UNITED STATES
DEPARTMENT OF THE INTERIOR
BUREAU OF LAND MANAGEMENTFORM APPROVED
OMB NO 1004-0135
Expires July 31, 2010**SUNDRY NOTICES AND REPORTS ON WELLS**
Do not use this form for proposals to drill or to re-enter an abandoned well. Use form 3160-3 (APD) for such proposals.

SM ENERGY WOULD LIKE TO REQUEST SOME CHANGES TO APPROVED APD FOR THE PDU 521. PLEASE SEE ATTACHMENT FOR DETAILS.

PDU #521

We would like to make the following changes to the PDU #521 APD.

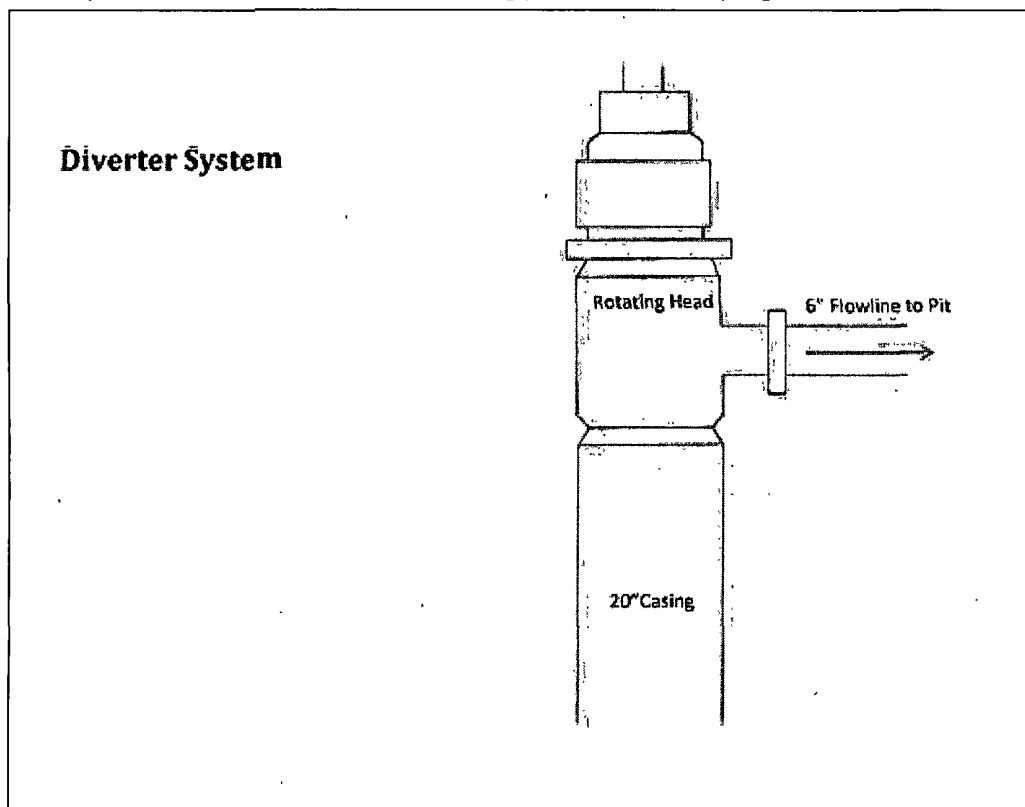
Change #2

Cementing program will be changed to:

Reason: Cementing products have changed since APD was submitted and approved
